Statement

Product Name: FGM840R LGA Module

**Model Number:** FGM840R
Hardware Version: R1.0

FGM840RAAMD-4X-04   FGM840RAAMD-0L-04A

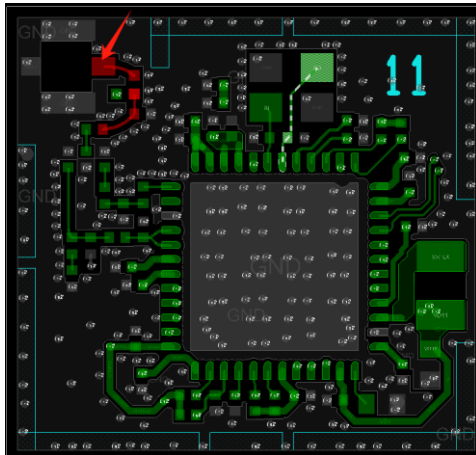
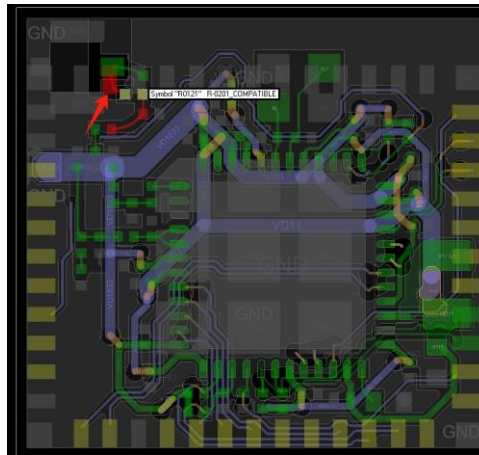
FGM840RAAMD-4X-04 and FGM840RAAMD-0L-04 both use RTL8720DF chipset, share the same chipset baseline, same software and hardware design, the primary difference lies in the antenna pedestal. FGM840RAAMD-4X-04 use IPEX antenna port, FGM840RAAMD-0L-04 use LCC pad port, Distinguish by changing the position of one resistor.

● **PCB changes**

FGM840RAAMD-4X-04	FGM840RAAMD-0L-04
use IPEX antenna port at TOP layer	use LCC pad port at BOT layer

Above changes won't impact the protocol and RF performance for same frequency. Your assistance on this matter is highly appreciated.
